Report to
Australian Energy Regulator

**Maximum demand forecasts for the Energex region –
update addendum.**

19th March 2010

Figure 3-1 Daily maximum demand vs temperature data and linear trends

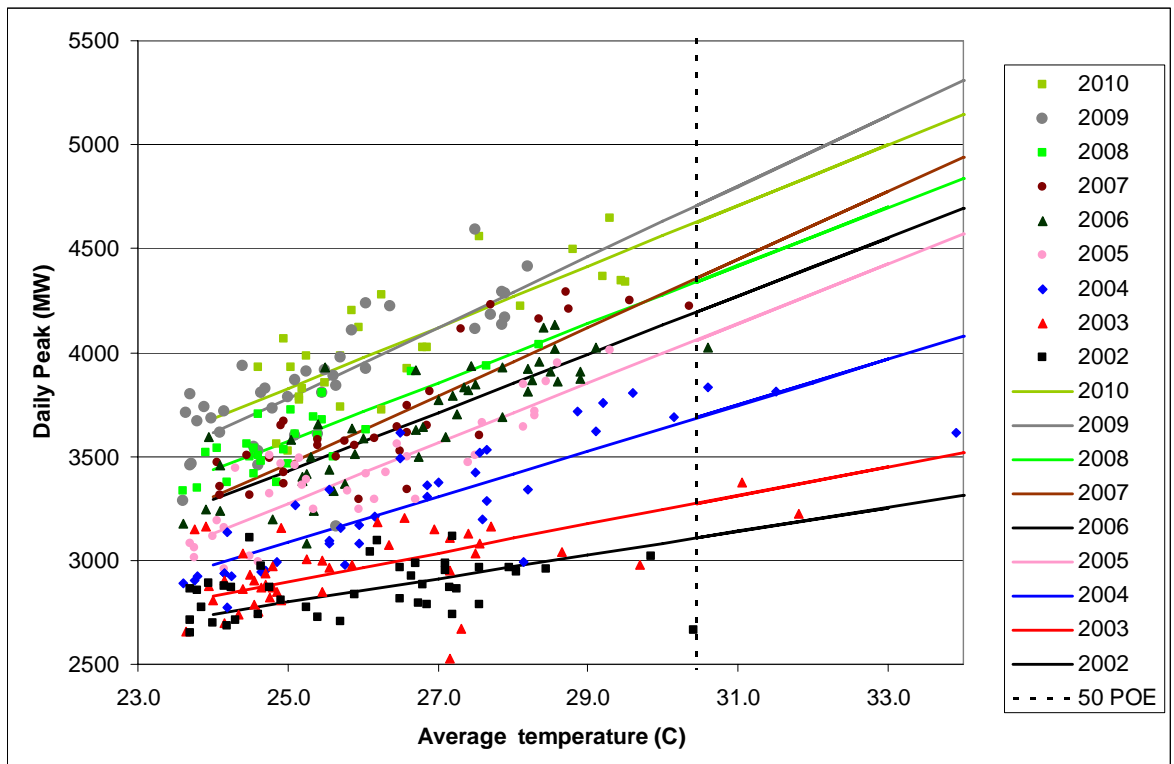
Figure 3-1 illustrates daily maximum demand vs temperature data provided by Energex, together with linear temperature sensitivities, for 2002 to 2010 (part summer to early February). Important points to note are:

1. The steady lift in the trends, with significant increases in slope (temperature sensitivity) from 2002 through to 2005, followed by more modest increases in 2006 and 2007. There was no growth in the trend in 2008 but growth resumed in 2009 - it appears to have stopped again in 2010 based on the part summer data available.
2. There are many years with lower temperature days with relatively high demand, for example 2004 and 2006, where demand on the higher temperature days is not much greater. This reinforces the need for care in assuming that high values at low temperatures will transfer to very high values at higher temperatures.

The coefficients for the regressions are tabled below. In view of the almost random variations in the constant term it is important not to draw any conclusions from the variations in the temperature sensitivity coefficient by itself. However, the zero constant model (not shown in the chart) does show consistent growth in the temperature sensitivity coefficients from year to year. Growth slowed from 6.75 MW/C/yr from 2002 to 2006 to 4.0 MW/C/yr from 2006 to 2010.

We note that the last NIEIR calibration of Energex summer MD data was in 2004/05, the last hot summer. It is not clear how NIEIR's model has been calibrated to changes since 2004/05 and as is evident in Figure 3-1 and the supporting table, rates of growth of weather sensitivity appear to have slowed substantially since then.

Figure 3-2 NIEIR forecasts of Queensland GSP growth, 2007 - 2015 and 2009 - 2015, % pa

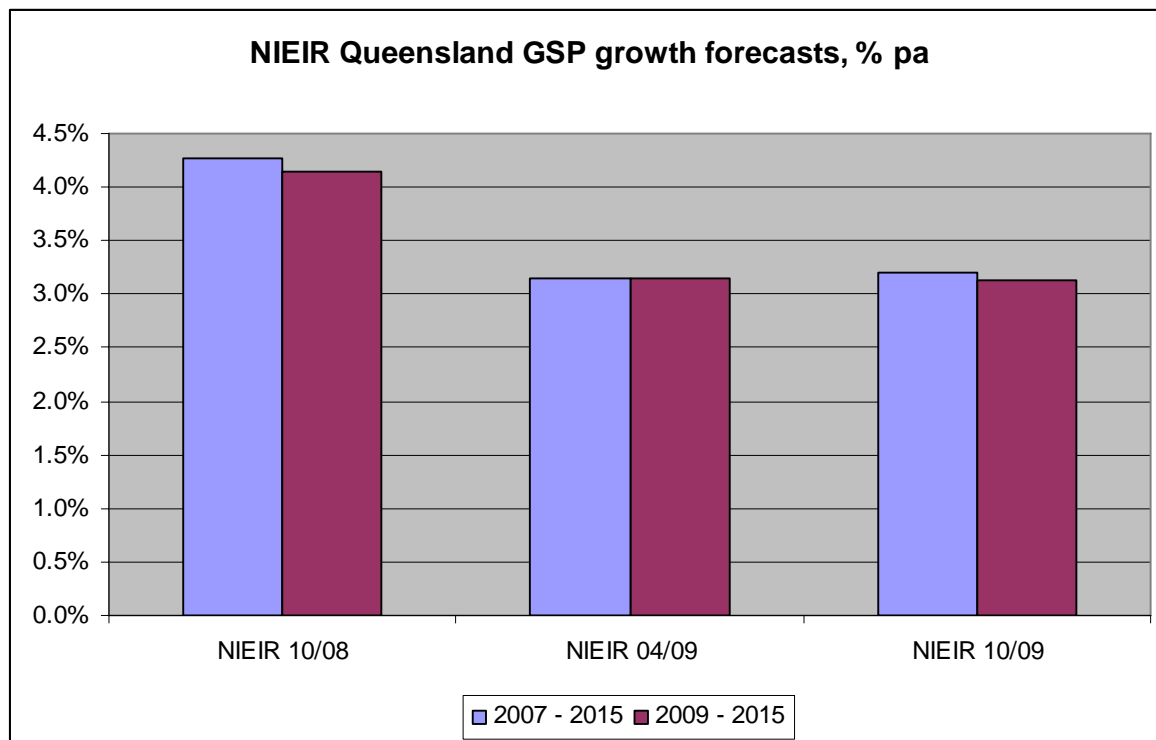
The GSP growth rates between 2007 and 2015 and 2009 and 2015 from the NIEIR October 2008, April 2009 and October 2009 reports are illustrated in Figure 3-2. As can be seen, there has been little overall change in GSP growth rates between the April 2009 and October 2009 reports, although the annual timing of GSP growth is different.

Based on the above analysis, MMA considers the overall changes in NIEIR economic growth rates between its April 2009 report and October 2009 report to be relatively small.

However, we consider the latest NIEIR economic growth forecasts to be the most timely currently available and have used these in the updated MMA model.

Figure 3-3 NIEIR forecasts of Energex 50% POE MD in a 50% summer, MW

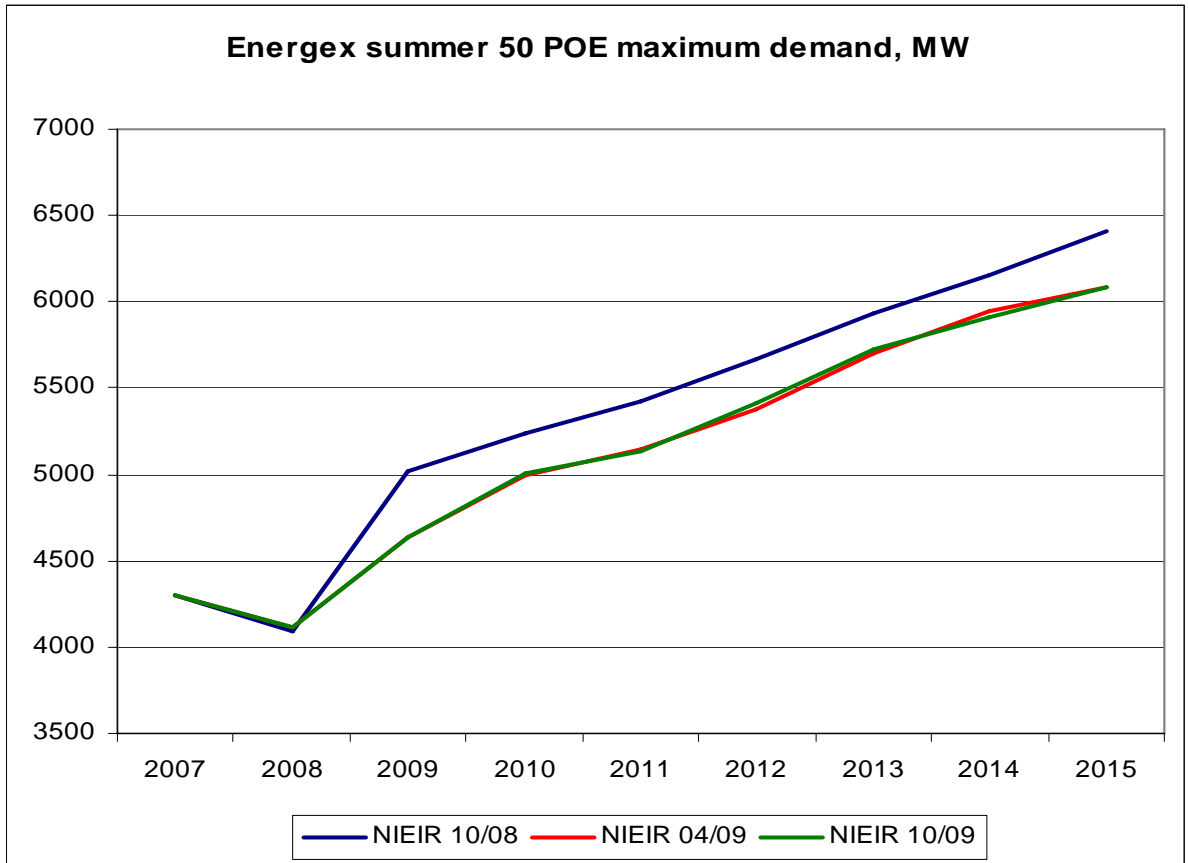
While NIEIR’s forecasts of total electricity consumption by 2015 have changed by over 4% between the April 2009 and October 2009 NIEIR reports, maximum demand forecasts, as measured by the 50% POE day in a 50% POE summer, have not changed materially – as seen in Figure 3-3. However, as expected, there has been a 4% or so average reduction in forecast summer MD between the October 2008 and 2009 NIEIR forecasts.

Figure 3-4 Linear regression analysis of Energex 2009/10 summer daily data

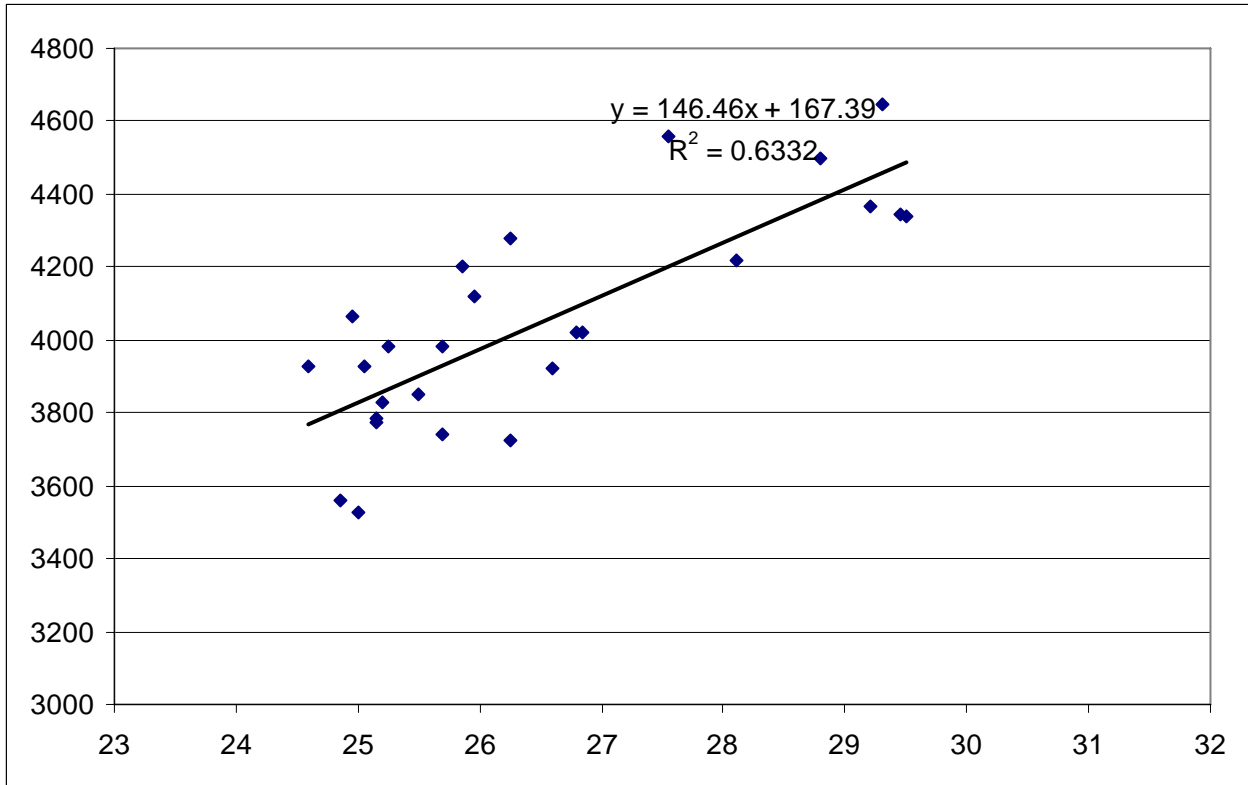
A simple linear regression analysis of the system maximum demand against the average of the daily maximum and minimum temperatures is presented in Figure 3-4 and presents an indicative temperature corrected MD for the 2009-10 summer.

Assuming a 50% PoE temperature of 30.5 C at Amberley the estimated 50% PoE for 2010 is between 4600 and 4700 MW, around 4634 MW.

Based on the evidence of the available data for the 2009/10 summer, and that of recent summers we can see no reason to change the model used by MMA and the starting point that it projects. If this data were to be used in a recalibration of Model B it would most likely result in lower MD projections because the 4634 MW estimate is below the Model B trend.
